Re: Powertech (USA) Inc.'s Response to the Request for Additional Information to Support the Environmental Review of its Application for a Nuclear Regulatory Commission Uranium Recovery License for its Proposed Dewey-Burdock In Situ Leach Uranium Recovery Facility in the State of South Dakota  
Docket 040-09075, TAC No. J 00533

**Response to U.S. Nuclear Regulatory Commission  
Request for Additional Information  
Powertech (USA) Inc. Dewey-Burdock Project  
Environmental Review of Application for a U.S. Nuclear  
Regulatory Commission Source  
Material License**

**Response to the U.S. Nuclear Regulatory Commission's (NRC)  
Request for Additional Information for the  
Dewey-Burdock Uranium Project  
Environmental Report Submitted August 11, 2009.**

**ER\_RAI Figure AQ-1**

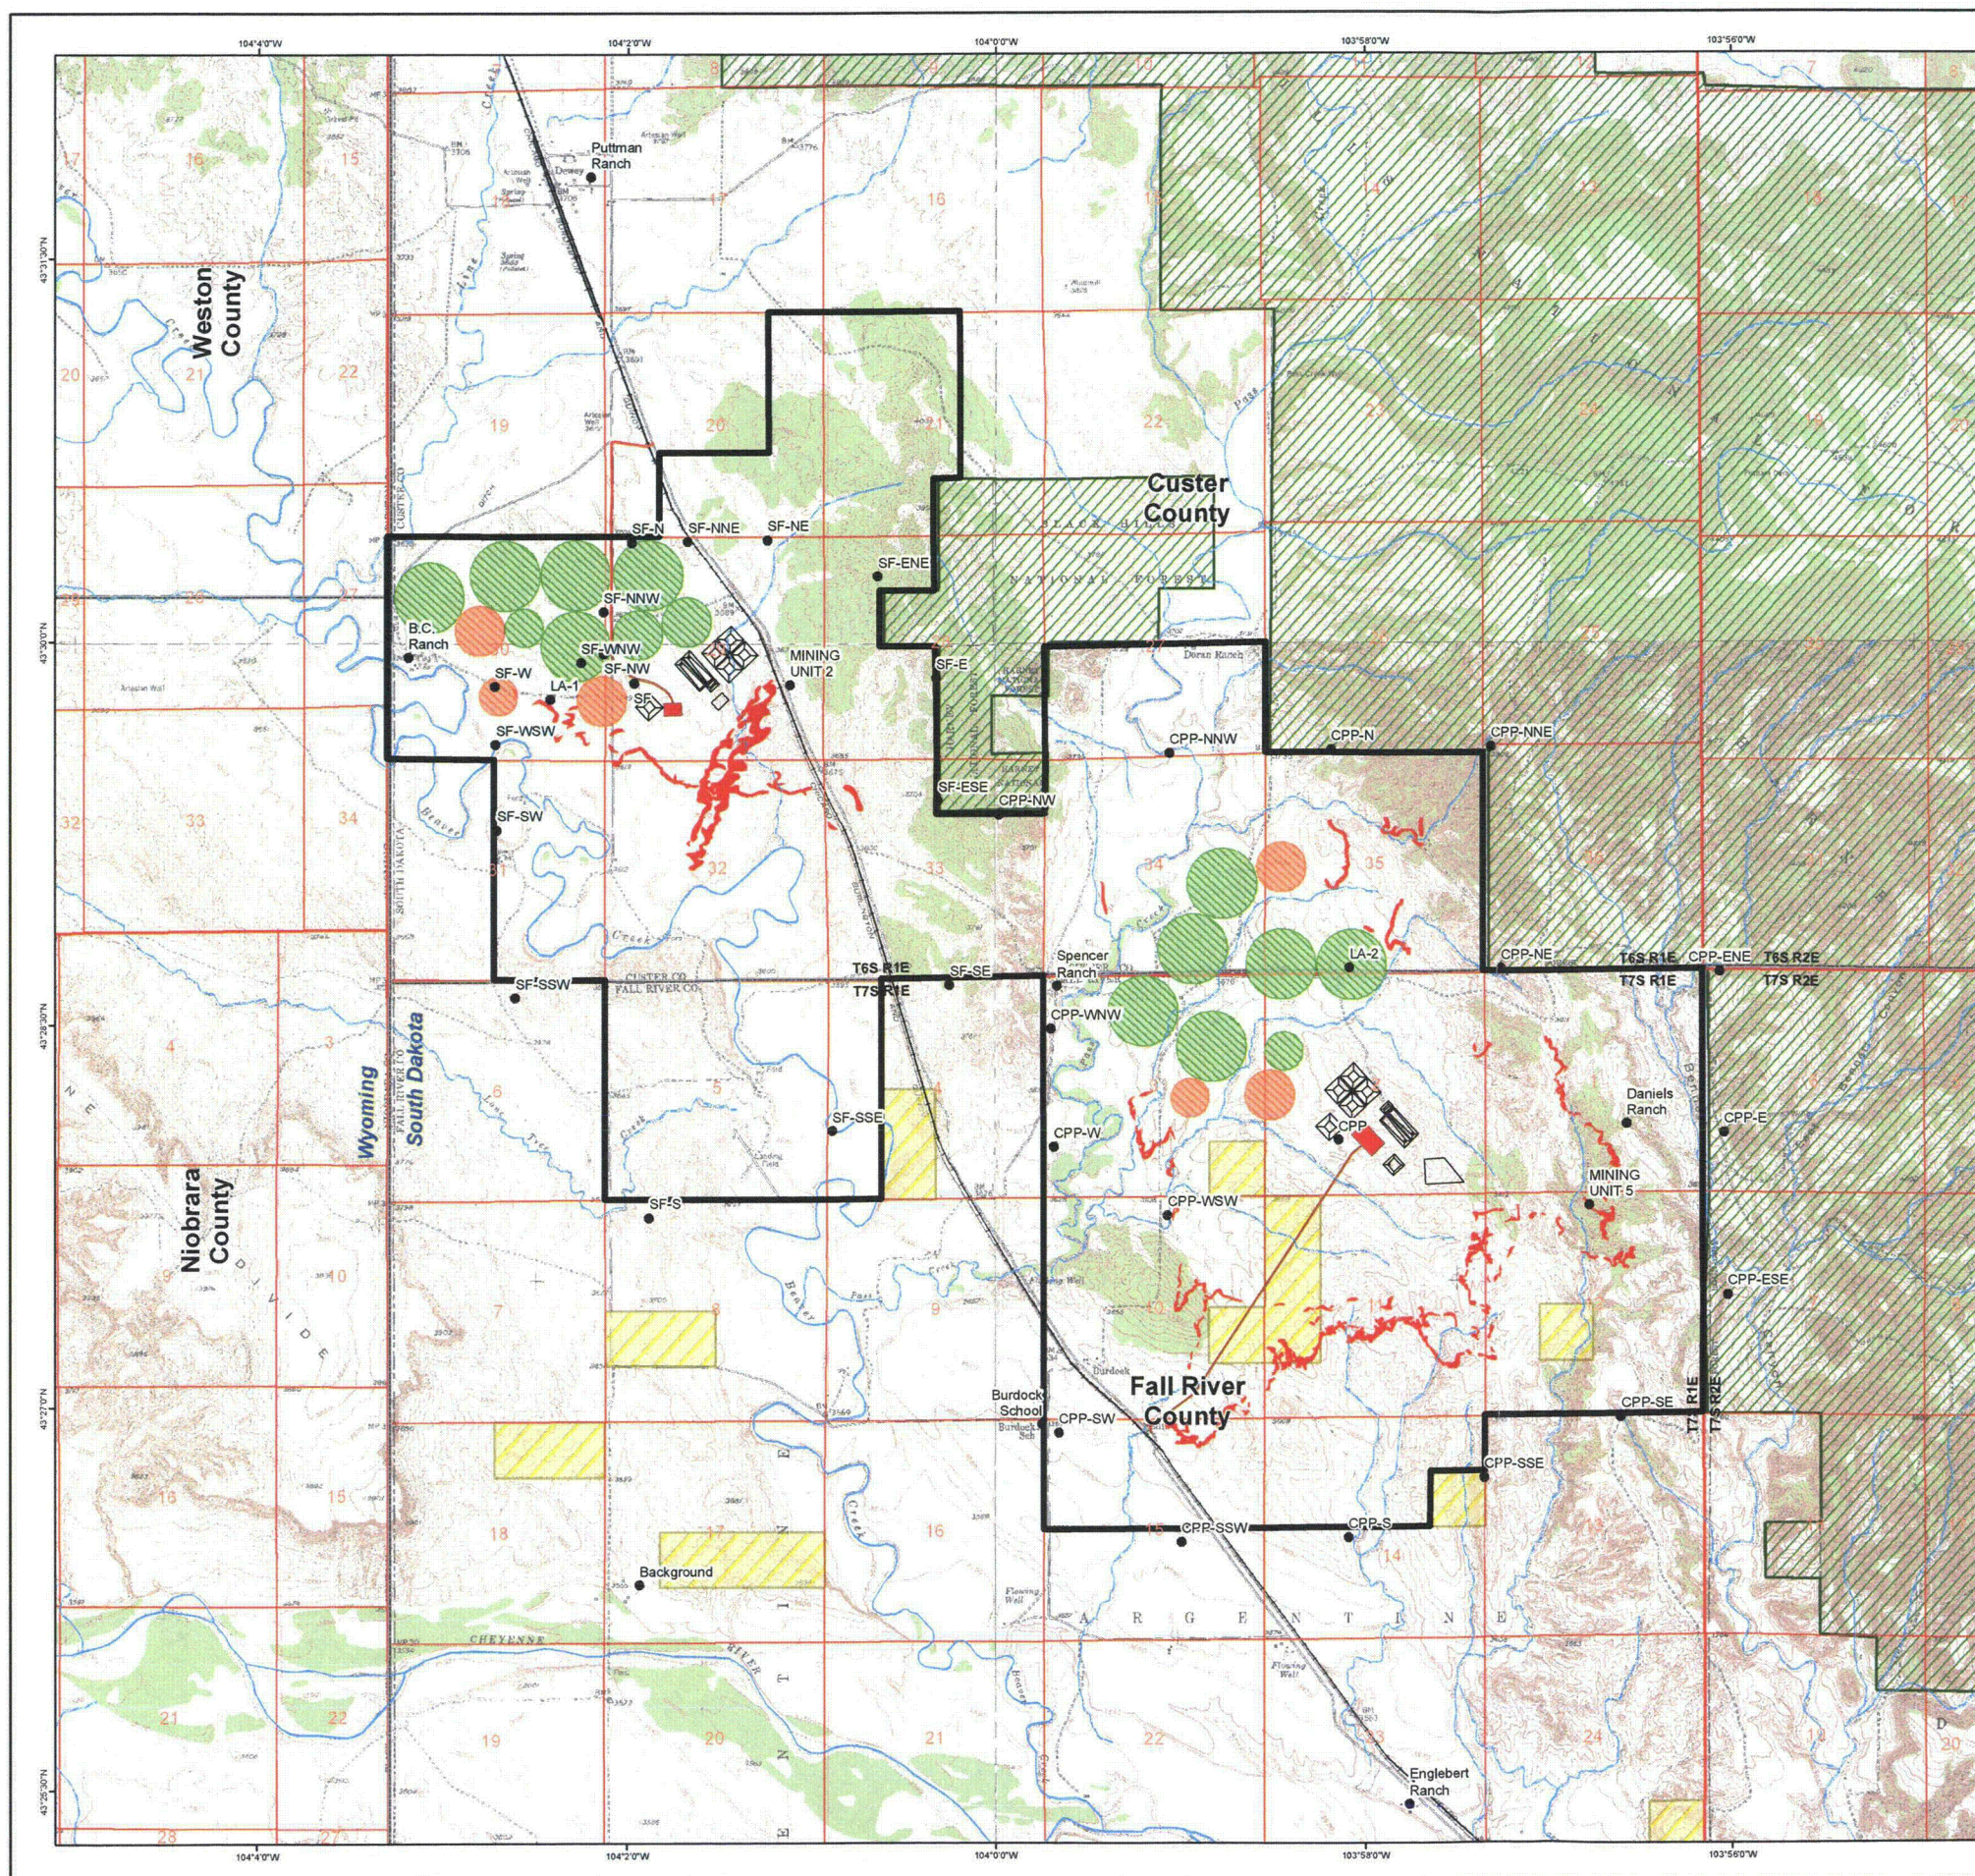
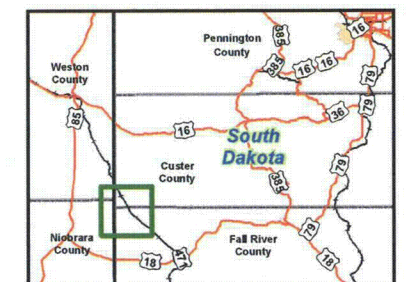
*Provide the rationale or supporting documentation regarding cumulative impact conclusion for air quality.*

The results of modeling indicate that National Ambient Air Quality Standards (NAAQS) will not be exceeded at any of the receptor sites as shown in **ER\_RAI Figure AQ-1**.

The project is located within an attainment area for NAAQS. Preliminary quantitative information is provided through the analysis described in the response to **ER\_RAI-AQ-1**. **ER\_RAI Tables AQ-8.1 through AQ-8.4** (Appendix ER\_RAI Air Quality, 2010) provide a summary of the results of the dispersion analysis (including atmospheric conditions), with maximum concentration values predicted at all specified receptors and a comparison to the National Ambient Air Quality Standards (NAAQS) criteria. All predicted concentrations are below the NAAQS standards; therefore no significant cumulative impacts would be anticipated.

**ER\_RAI Figure WR-3.1: Location of Confined Portion of the Fall River Aquifer**

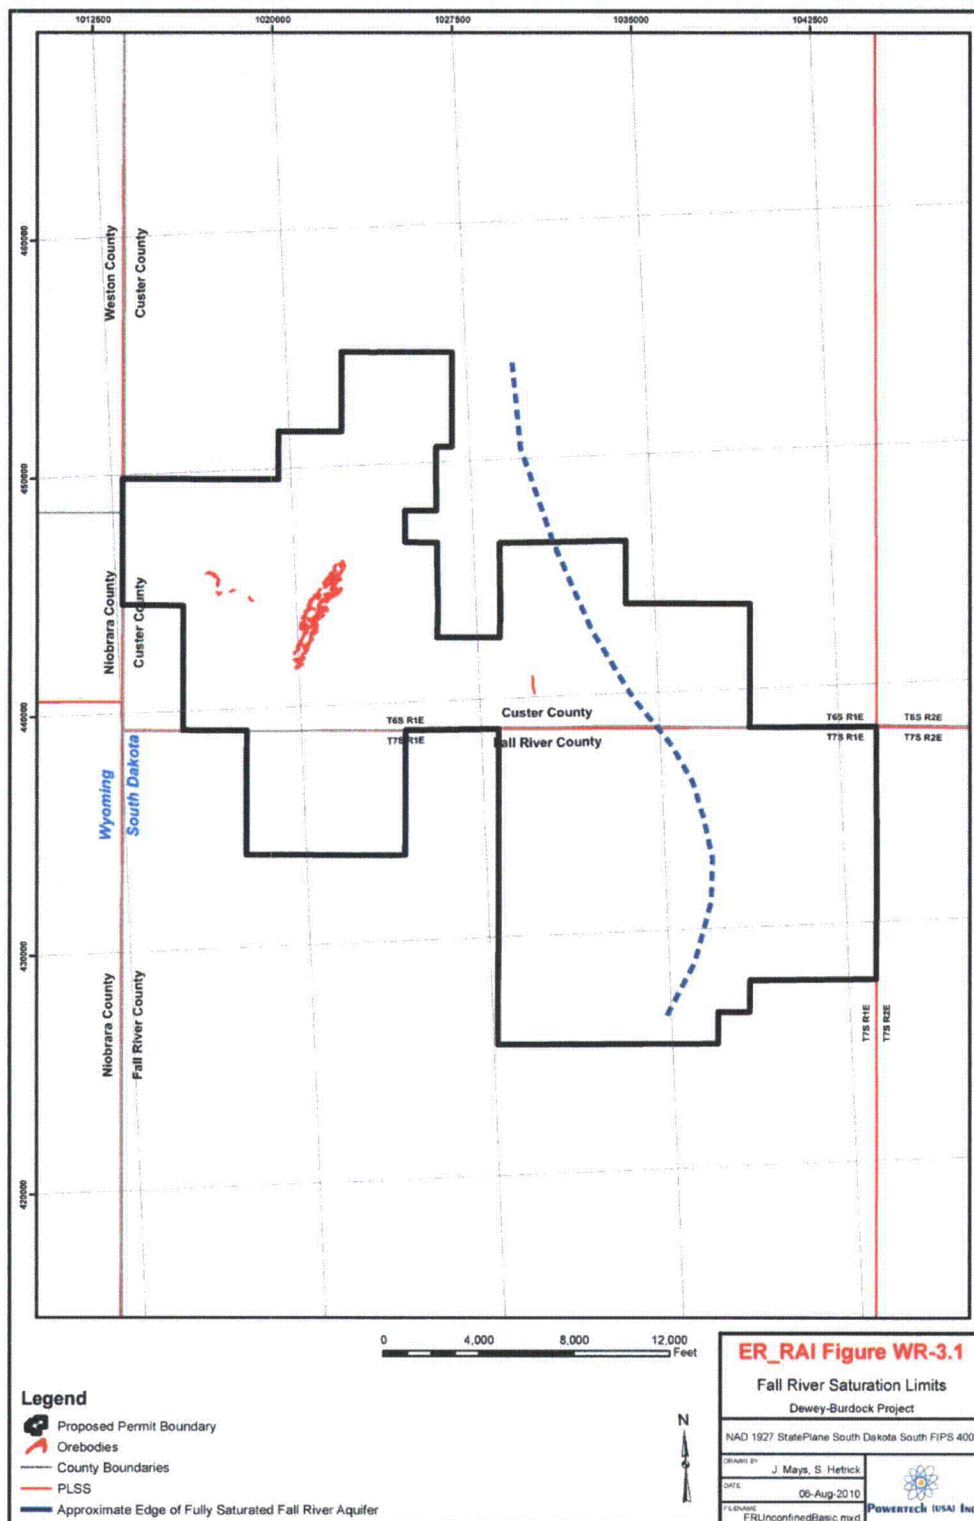
***Provide information on ISR operations in unconfined portions of the Lakota and Fall River aquifers in the Burdock portion of the project area.***

***1. Whether Powertech plans to conduct ISR operations in unconfined portions of the Lakota and Fall River aquifers in the Burdock area identified during delineation drilling and aquifer pump testing.***

***2. If the answer is yes to 1 above, information on well field design and construction and how Powertech plans to control and monitor production fluids in unconfined production zones.***

Proposed activities relative to estimated unconfined zones in the Fall River and Lakota aquifers are depicted in **ER\_RAI Figure WR-3.1** and **ER\_RAI Figure WR-3.2** respectively. The figures have a dashed-line estimating the approximate location at which each aquifer becomes saturated moving away from the outcrop where the potentiometric surface is at the same elevation as the top of the formation. The estimated boundary is approximated using the intersection of the potentiometric surfaces generated from water level measurements and the top structure contour of each respective aquifer and thus not highly accurate, and not confirmed with many data points. More precise measurement of the unconfined portions will be determined during an additional hydrogeological investigation prior to well field development. For the initially proposed well fields, Burdock Mine Unit I, and Dewey Mine Unit I, conditions are well confined with water levels several hundred feet above the top of each aquifer and confined conditions measured in aquifer pump tests.

Powertech (USA) plans for ISL operations within potentially unconfined portions are limited to the eastern side of the project in portions of Burdock Mine Unit II and Burdock Mine Unit IV in the Lakota Formation. Though ore bodies are present in unconfined portions of the Fall River formation on the eastern side of the permit area, Powertech (USA) does not propose to mine in those Fall River ore bodies in this license application. Furthermore, Powertech (USA) has limited its proposed operations in the Fall River Formation to the Dewey portion of the project. **Supplement Exhibit 3.1-4 Revised** "Future Mine Units" depicts ore bodies which Powertech (USA) plans to mine in the project.

ER\_RAI Figure WR-5.1: Distribution of Water Rights within the Madison Aquifer.

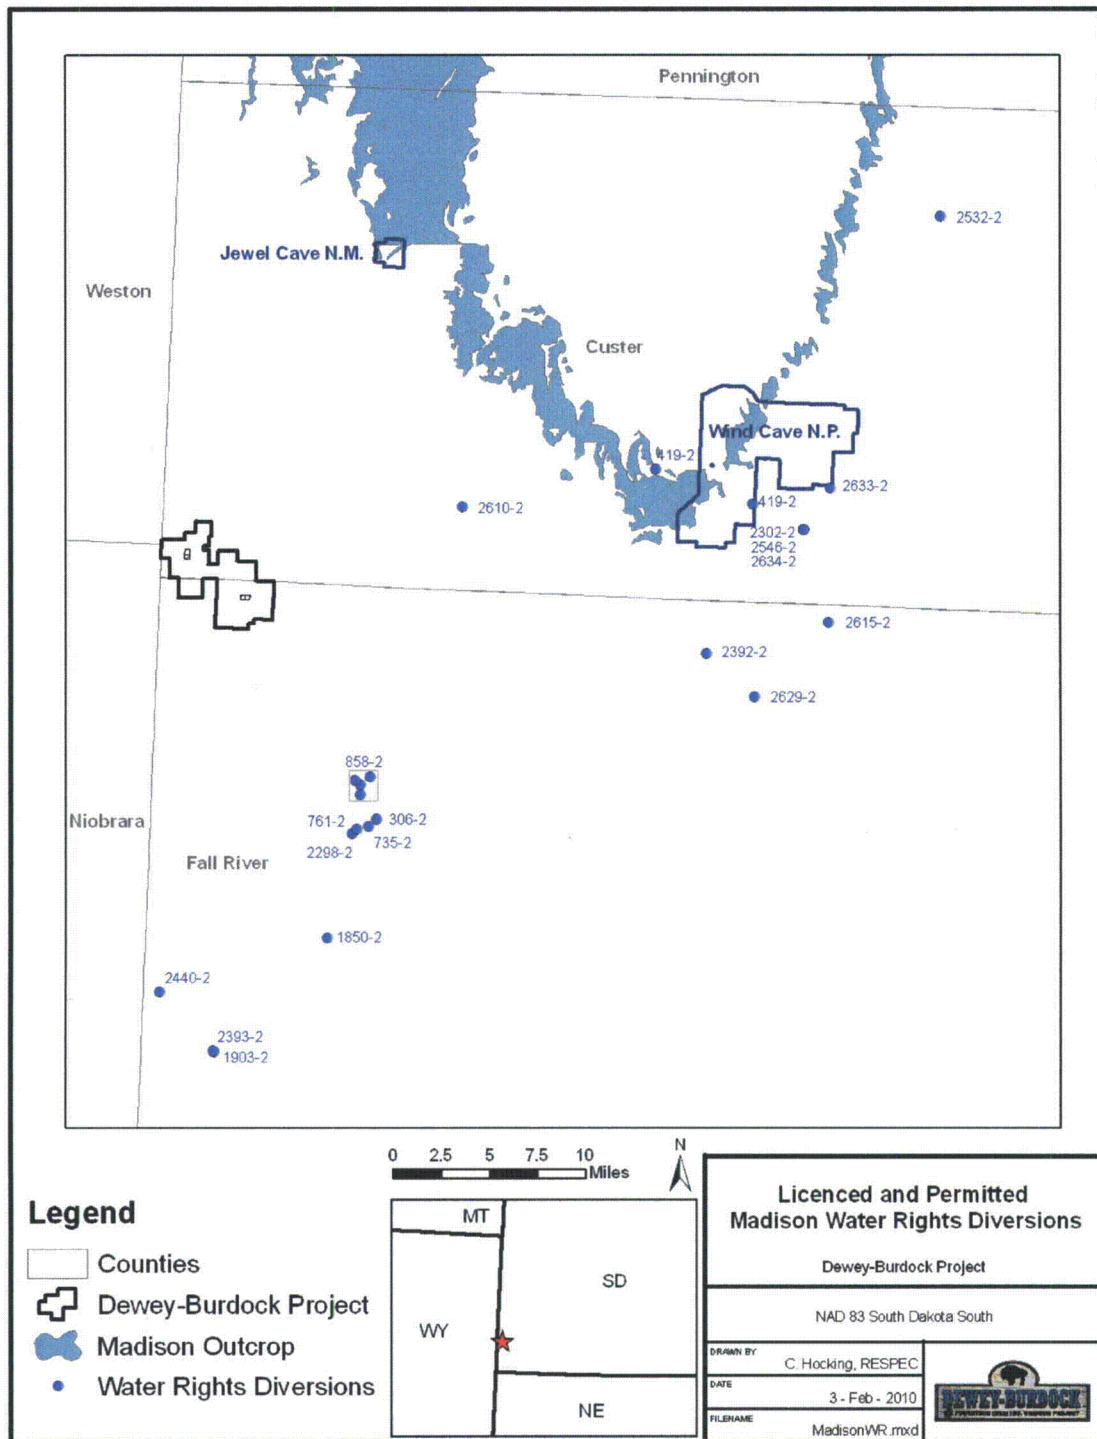
***Provide information on the status of obtaining water appropriation permits for use of water from the Madison aquifer.***

- 1. Please provide information on the status of obtaining a water appropriation for use of Madison aquifer water during operations and aquifer restoration.*
- 2. If water rights permit cannot be secured for the Madison aquifer provide information on the potential alternatives to meet water requirements during operations and aquifer restoration and how each alternative would impact groundwater levels, flow rates, and flow directions.*

The water rights application is planned to be submitted to DENR during 2010. There is currently limited use of the Madison water within the immediate vicinity of the project area and sufficient availability to meet the needs of the project. There are no reasons to expect that the permit would not be accepted and it is believed that the proposed project meets all acceptable criteria for obtaining a permit.

**Figure SOC-1.1: Unemployment Rates, Wyoming, 2000 – 2009**

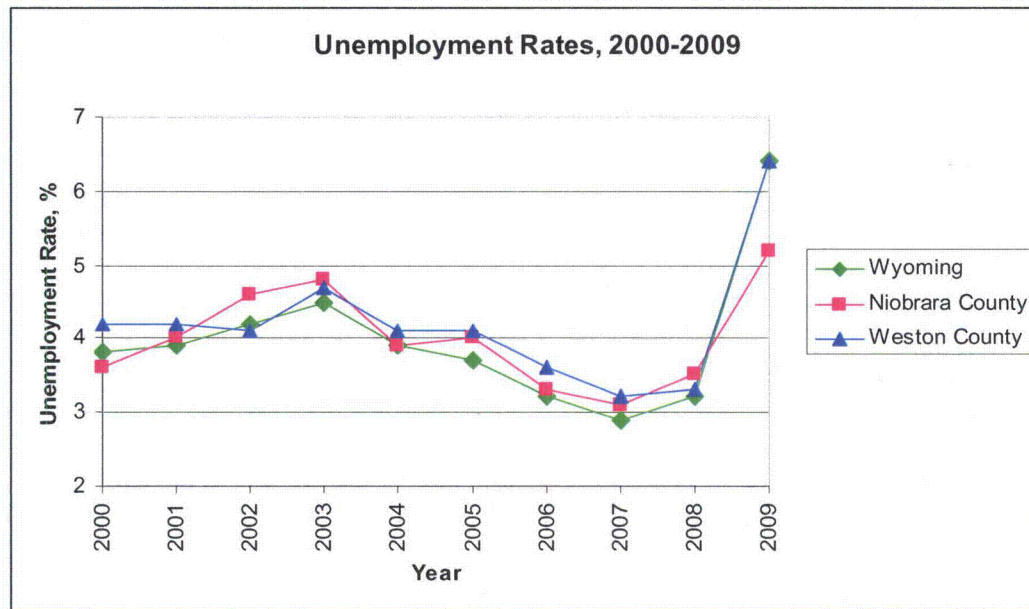
- 2. Provide annual average labor, employment, and income characteristics for direct social zones within the region of interest for Wyoming, similar to data provided in ER Section 3.10.3 for South Dakota.*

Unemployment trends for Niobrara and Weston Counties and Wyoming's state-wide rate over the last decade are presented in **Figure SOC-1.1**, which plots the average unemployment rate for each year determined from monthly county and state data provided by the WDE's Local Area Unemployment Statistics (LAUS).

As the figure shows, the average unemployment rates have remained similar between the Counties of Niobrara and Weston and the State of Wyoming. No major disparities between county and state trends have occurred in the last decade.
